SUNSHINE COAST REGIONAL DISTRICT

ADDENDUM NO. 6

Invitation to Tender No. 2137017

Well Field Development and Water Treatment Plant

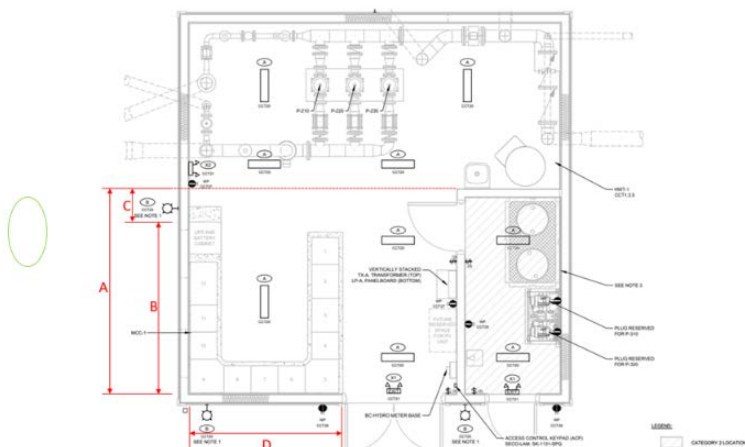
Question: Can you please confirm whether all the ductile iron watermain pipes should be restrained on all fittings and gate valves?

Yes correct
